PARADISE BAKERY & CAFE #610048
HOLLY PLAZA -
6550 HOLLY AVE. NE SUITE A-8
ALBUQUERQUE, NM 87113

**CITY OF ALBUQUERQUE
ADMINISTRATIVE APPROVAL (AA)- SITE DEV PLAN AMENDMENT
REVIEW SHEET**

APPLICATION #: 11AA 10106	PROJECT #: 1004246
PROJECT NAME: 6550 Holly Ave NE	
APPLICANT or AGENT: Tammy Korte	
PHONE # and E-MAIL: 314-415-2400 tkorte@arcv.com	
ZONE ATLAS PAGE: C-18	
ADMINISTRATIVE APPROVAL (AA) for:	EPC CASE DRB CASE

DESCRIPTION OF REQUEST: Need to attain Administrative Amendement for the outdoor dining and exterior work.

SHEET NO:
A-1.0
SITE PLAN
NEW CONSTRUCTION
FILE NUMBER: 1144

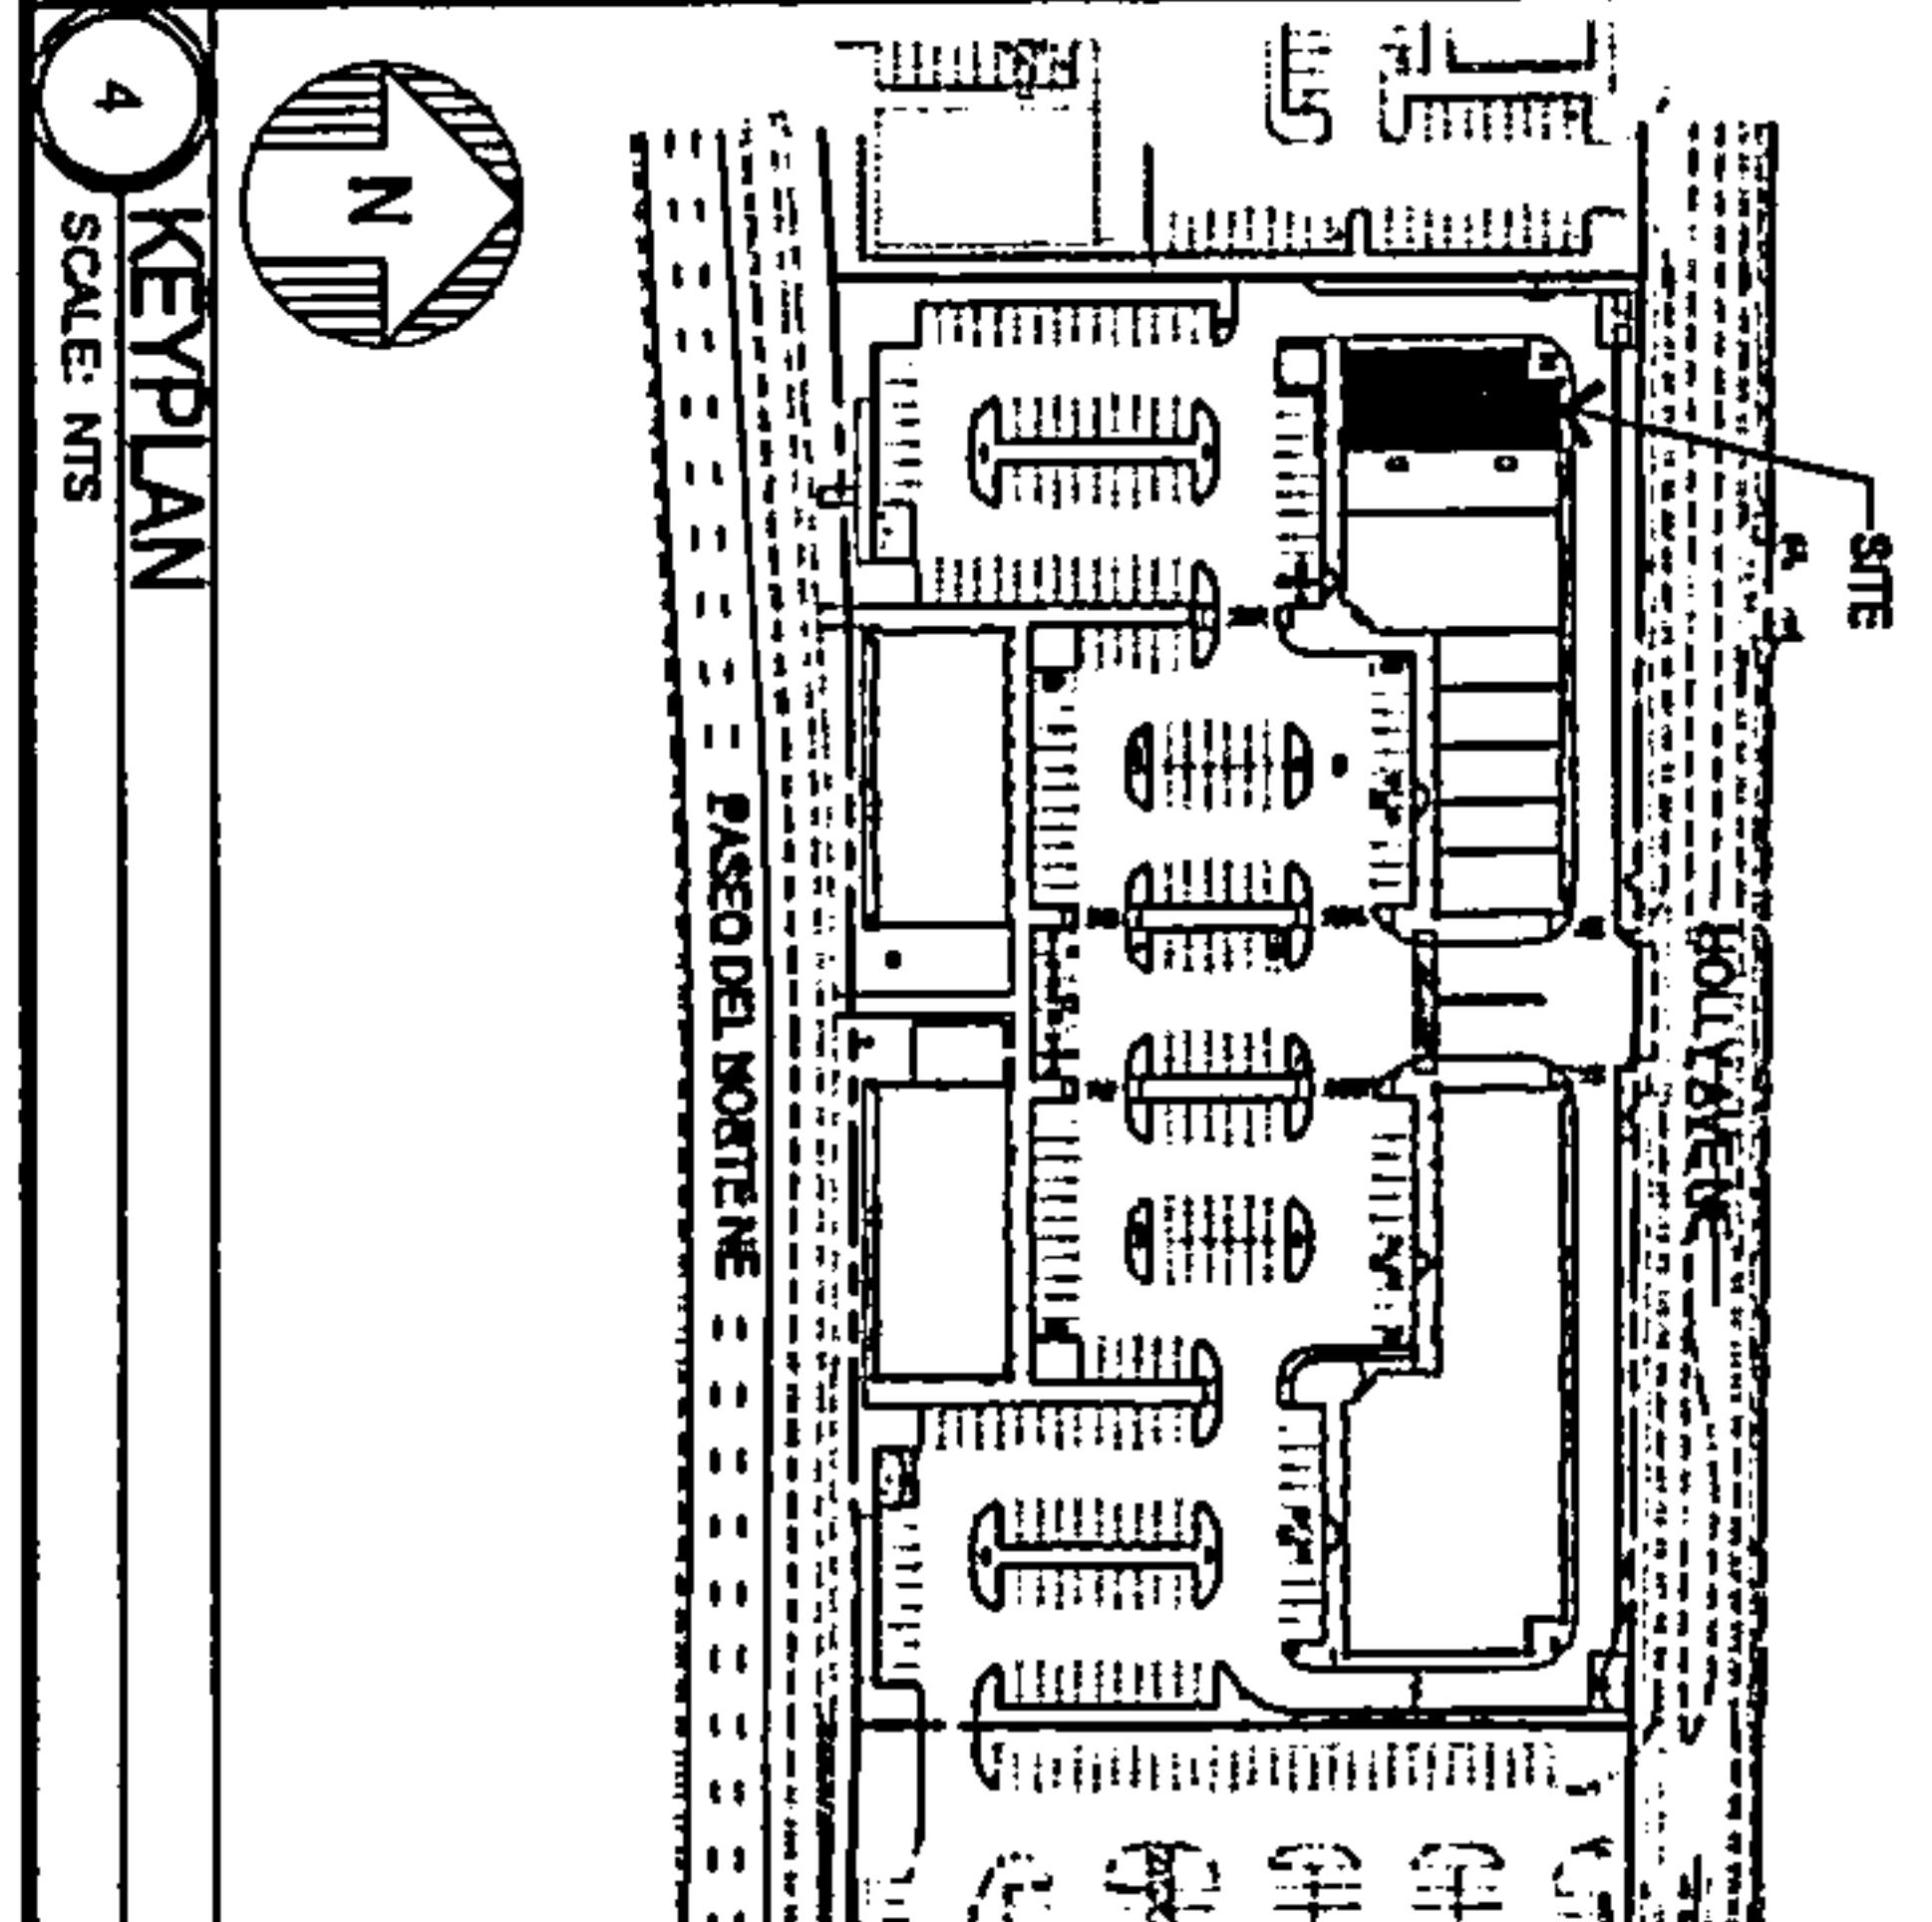
PLANS DISAPPROVED:	DATE: <i>07/08/11</i>	DATE:
PLANS APPROVED:	DATE: <i>08/10/11</i>	DATE:
COMMENTS: • NEED CORRESPONDENCE FROM TERRA WEST APPROXING/PERMISSION FOR USAGE OF THEIR SITE PLAN AS PART OF YOUR SUBMITTAL FOR BLDG PERMITS		
• PROVIDE GEOMETRY INFO FOR PROPOSED INFRASTR. W/IN PARKING AREA (W'S, L'S & R'S = 15' MIN)		
• NEED APPROVAL FROM NMDOT FOR PYLON SIGN ENCRACHING INTO THEIR ROW (AIR SPACE)		
• LOSS 2 PARKING SPACES: WILL THIS IMPACT OVERALL RPTD PARKING CALCULATIONS? VERIFY		
• WILL BE STAMPING THE SUBPLAN? ARCHITECT? SIGN/STAMP?

- revised Parking Table for Lot A on Sheet A-1.0 with reference to Variance 11ZHE-80226
- revised elevation for entry sign with backlit, metal channel letters
- revised elevation for rear signs to fit within designated sign area
- revised elevation for side sign to be centered between designated sign areas and within the top and bottom of designated area

Regarding the proposed occupancy and brick paver patio in Holly Plaza, parking calculations are different for retail space and restaurant space. The remaining retail would require 75 parking spaces, and your proposed restaurant would require one space for each four seats, or 28 spaces (81 seats inside, 32 seats outside). A variance from the Zoning Code Parking requirements would be required prior to approval of the site plan, or the layout would need to be revised to show a maximum of 60 seats. Once one of these options has been completed, please find room on your Sheet A-1.0 to place a revised parking table for Lot A (similar to the site data on the approved site plan).

Response: The overall parking for our lot required is 90 spaces. 92 spaces were provided, the loss of 2 spaces keeps our counts within requirements. See new site data on the provided approved site plan.

Response: The Architect will be signing the architectural site plan (Sheet A-1.0) provided in this submittal.

To simplify the revised application, I suggest we eliminate Sheet EQ-2.1 altogether and simply incorporate the above note with the revised parking table to be placed on Sheet A-1.0. The revised table for Lot A would indicate 15,130 SF RETAIL, 60 SEAT RESTAURANT, TOTAL PARKING REQUIRED 90 and ditto for PARKING PROVIDED.

DRAWING NAME
 V-205a2

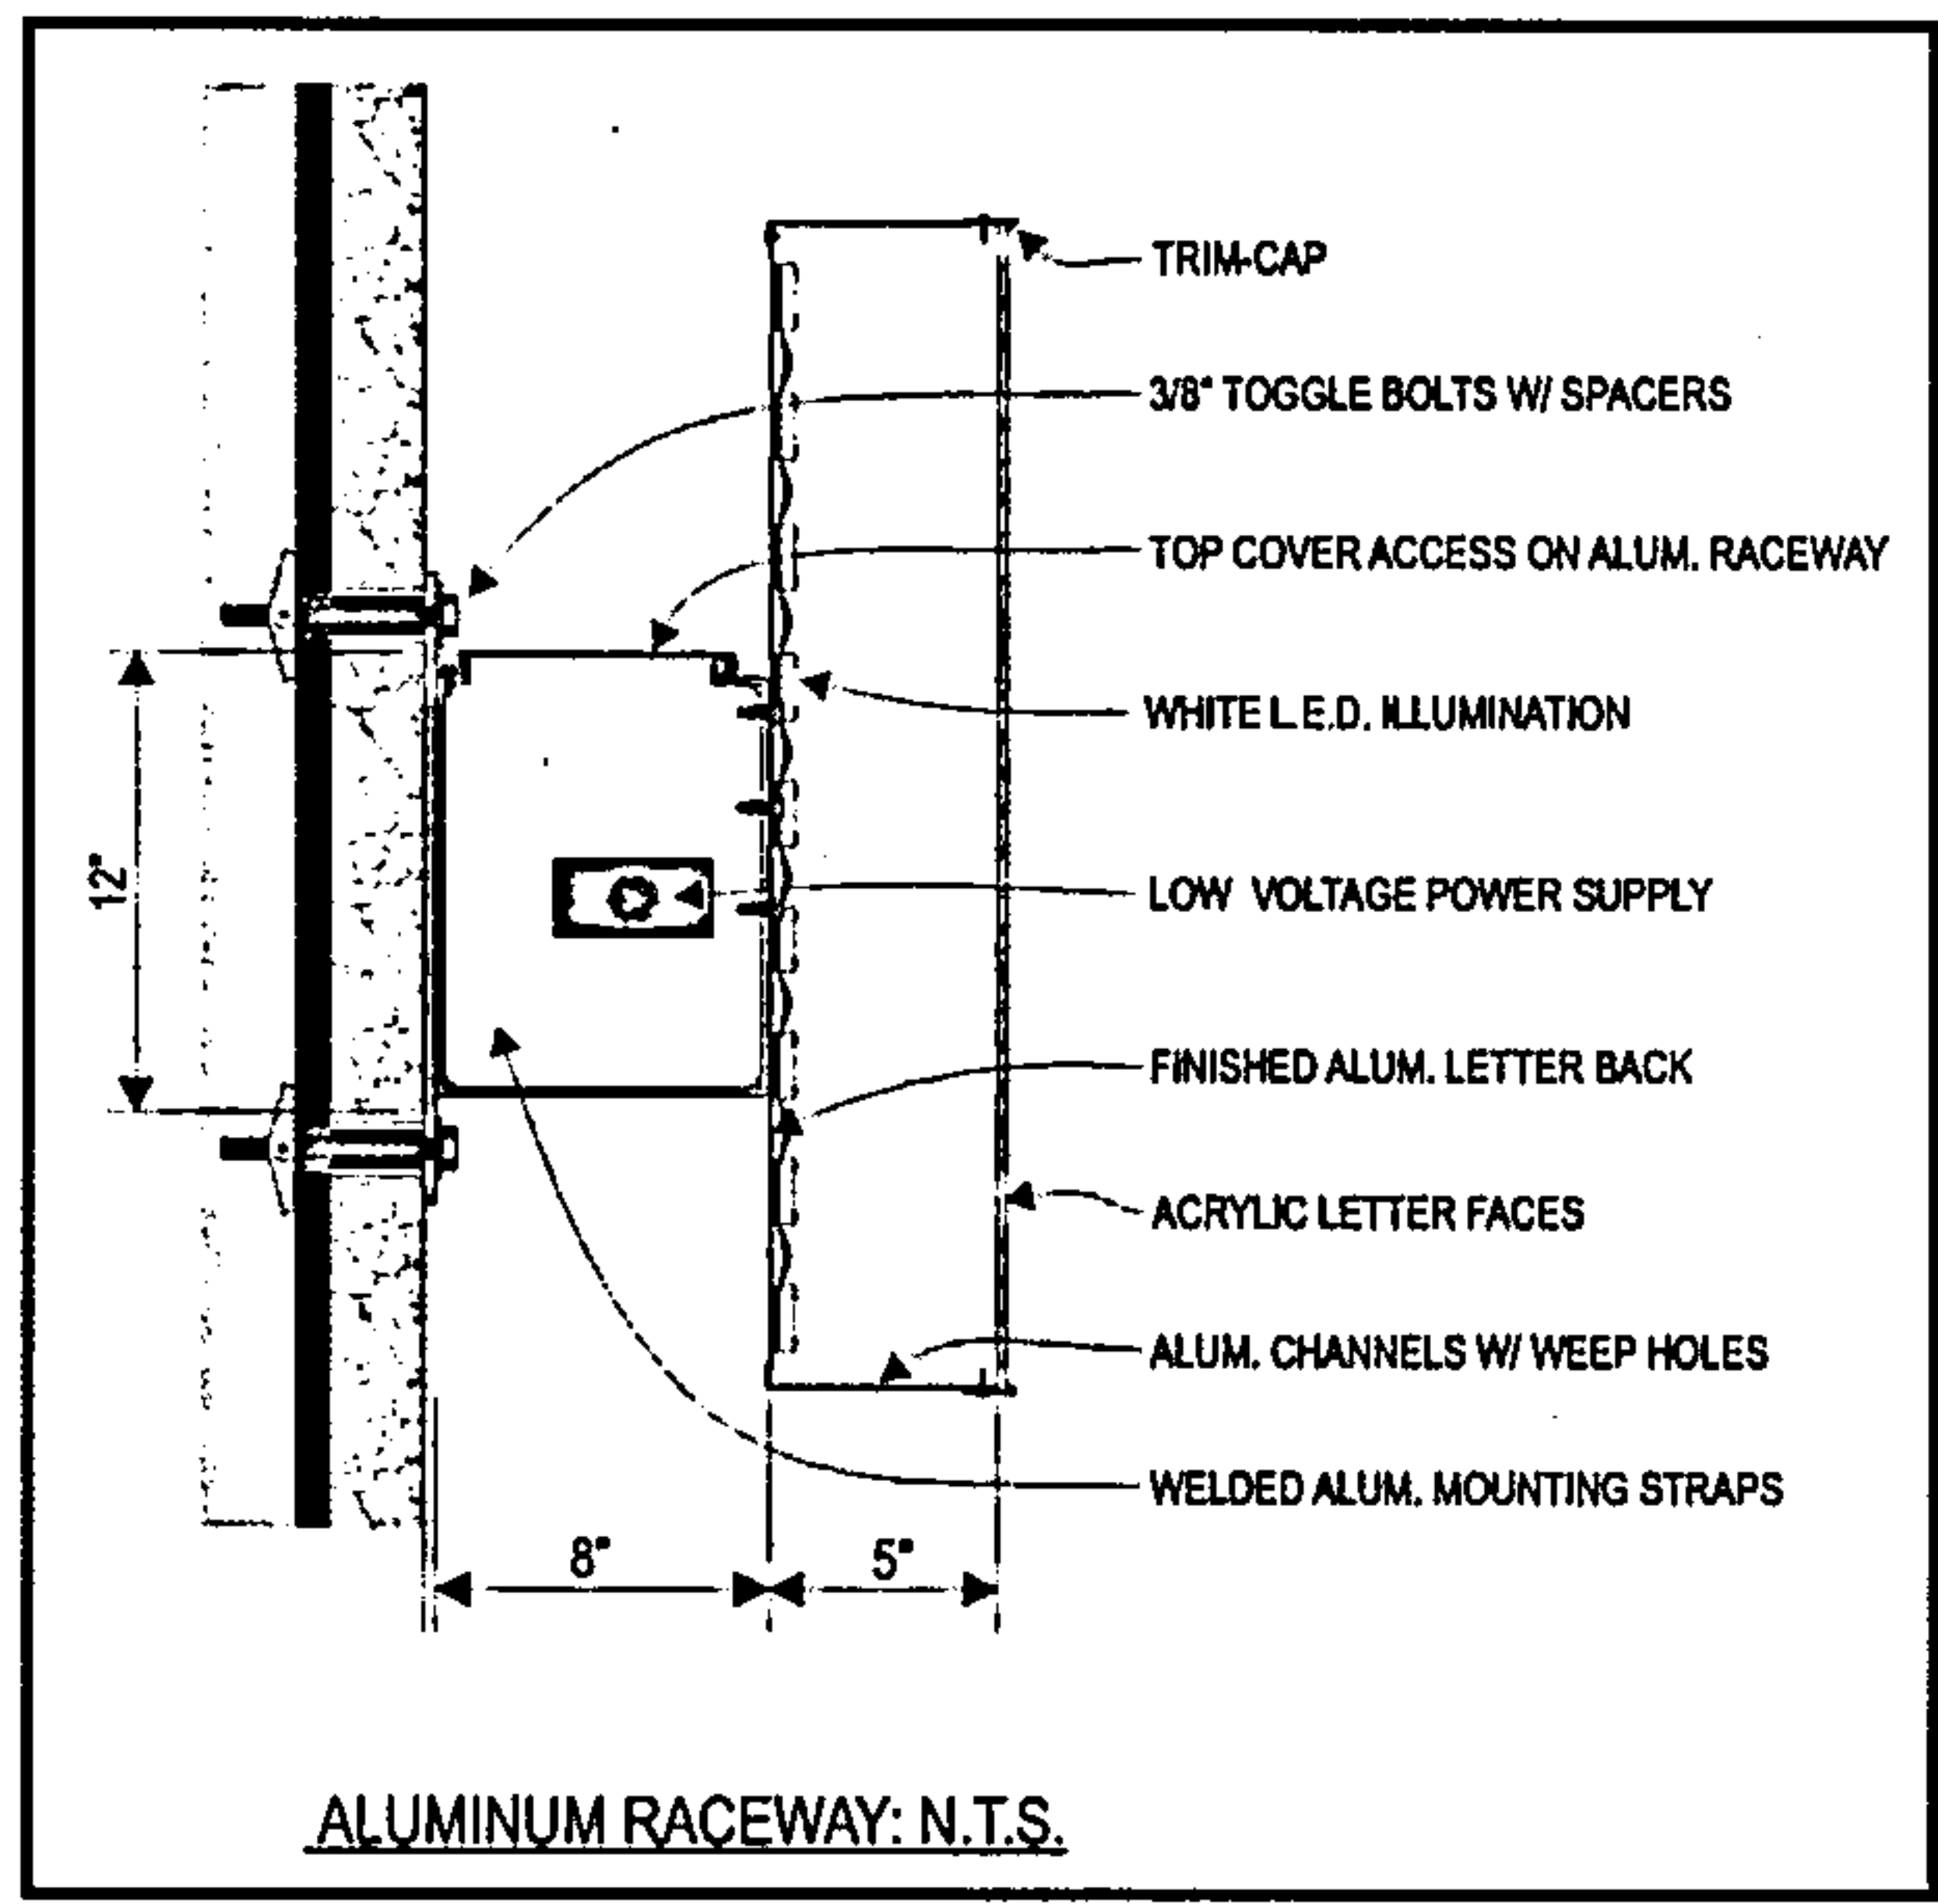
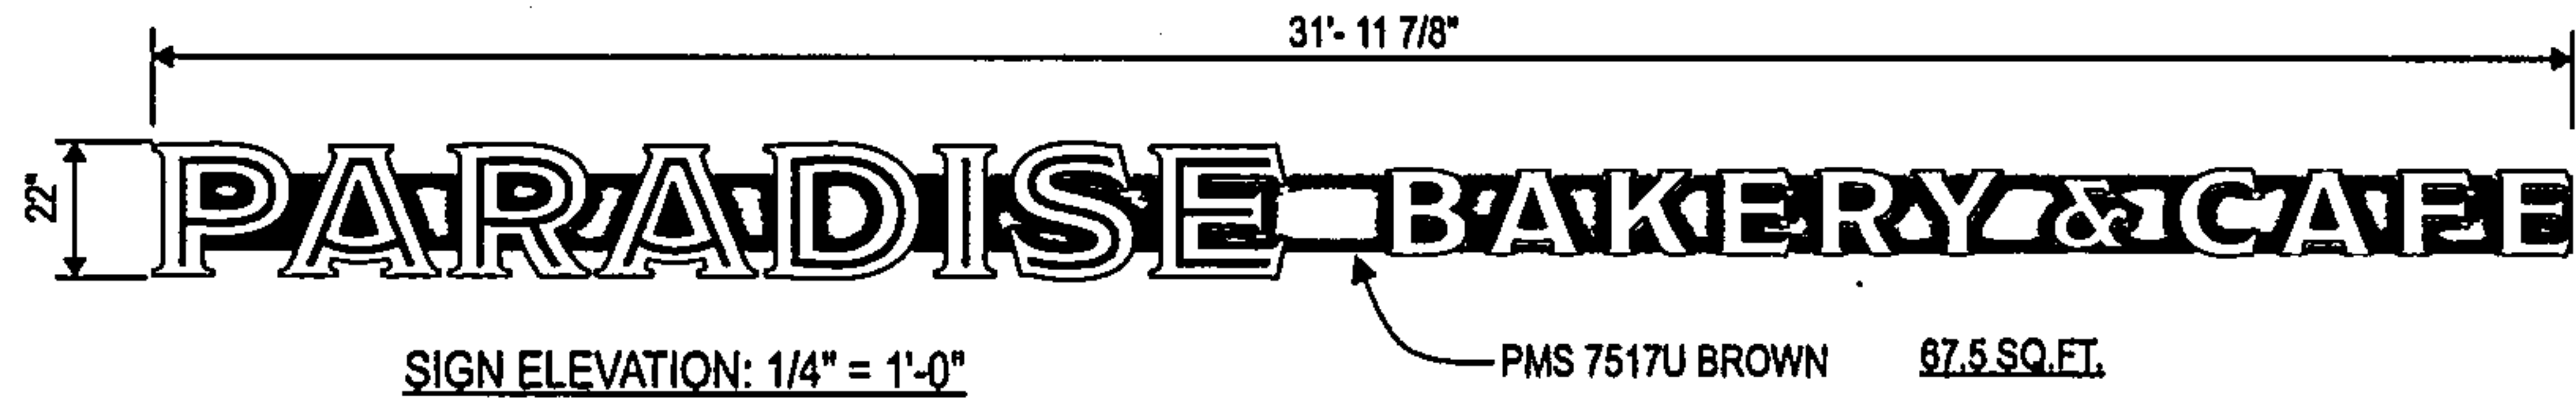
The proposed sign drawing V205a2 for internally illuminated, white channel letters with black inlays and brown painted raceway will be acceptable for approval of the submitted Administrative Amendment. The reference to "MOTHER BREAD LOGO" would need to be deleted from the text on the drawing.
